**THE GARDENS AT NORTH
CAREFREE
FINAL DRAINAGE REPORT
EL PASO COUNTY, COLORADO**

PROJECT NO. 187608744

January 21, 2019

PCD File No: SF 195

Project = Gardens at North Carefree
 Inlet ID = Proposed Type R Inlet - DP D

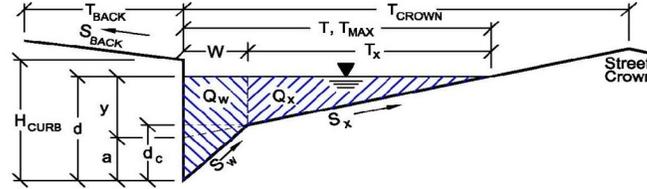
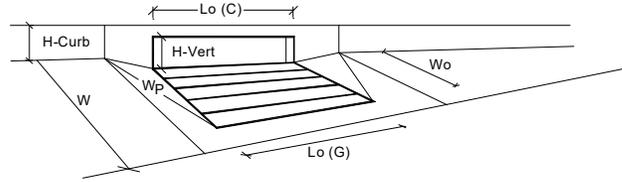
The inlet does not have the capacity for the proposed flow. How far will the water pond into the street. Please provide explanation in the narrative at this design point.

North Pond

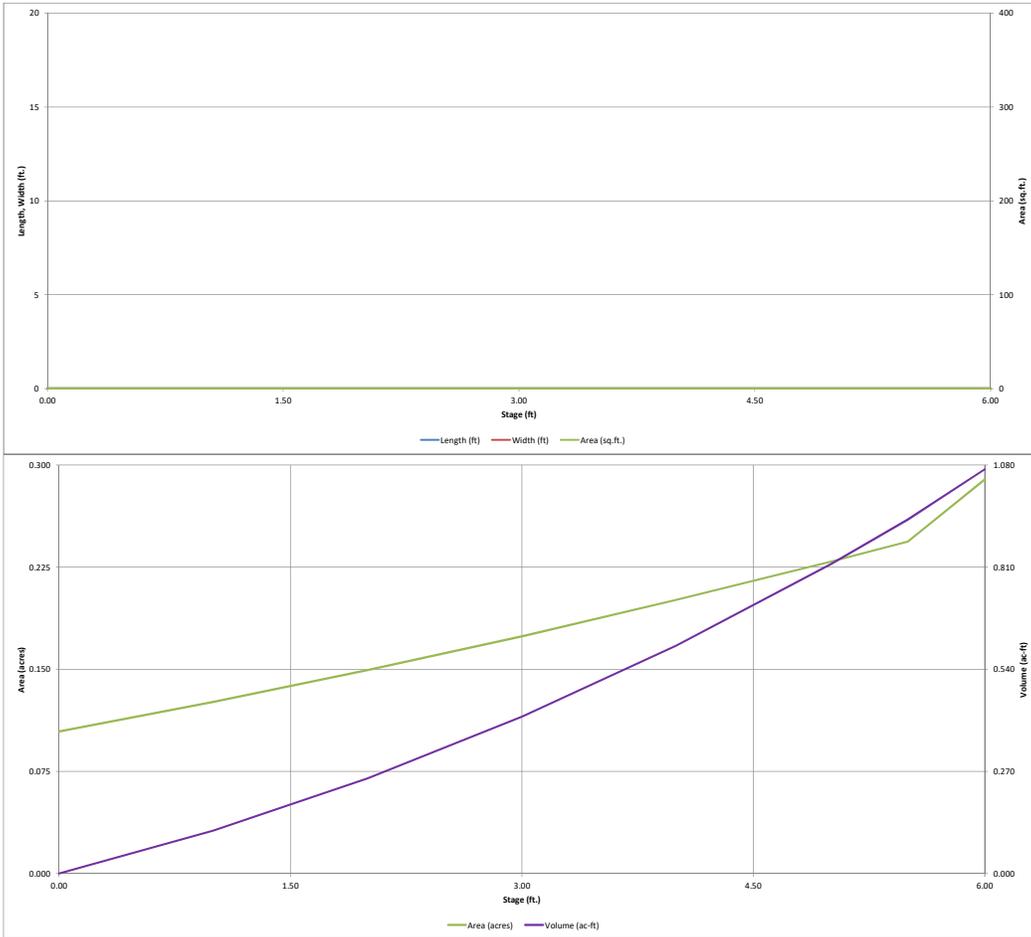
review 2: Adjust the design so that release is equal to less than pre-development.
Review 3: Unresolved

South Pond

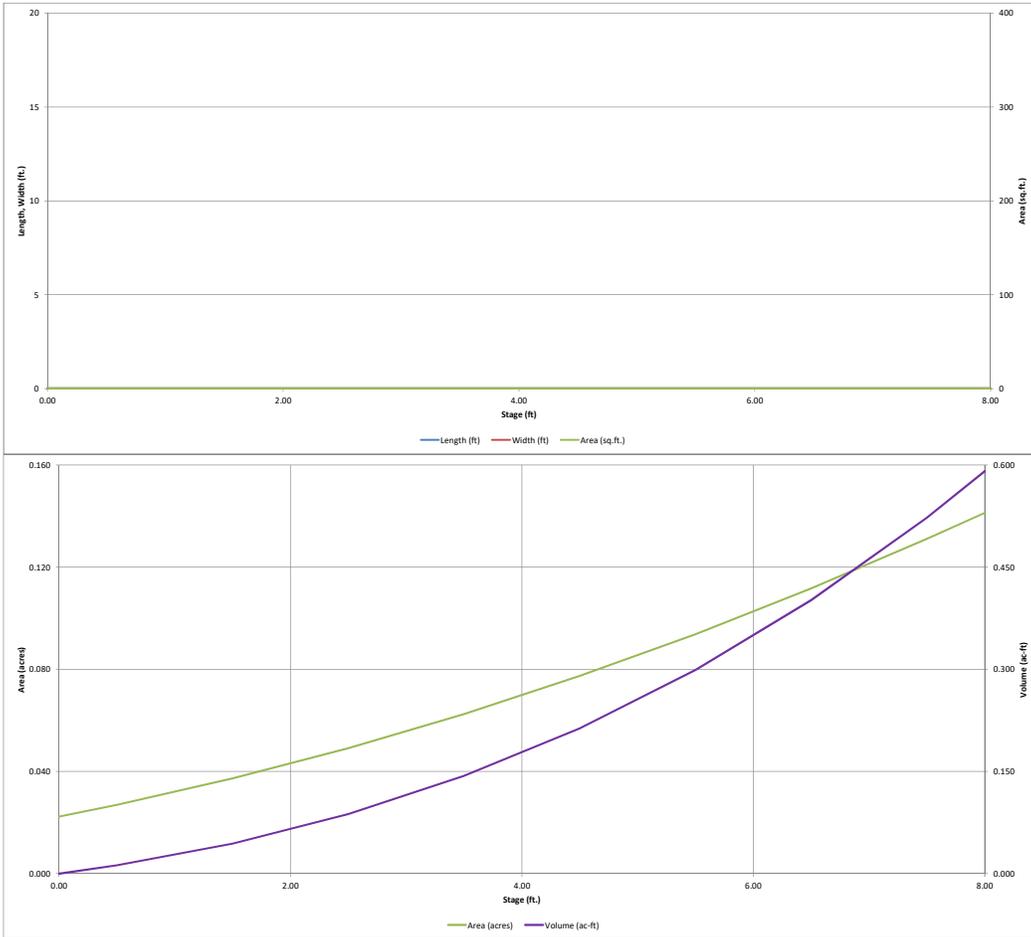
review 2: Adjust the design so that release is equal to less than pre-development.
Review 3: Unresolved
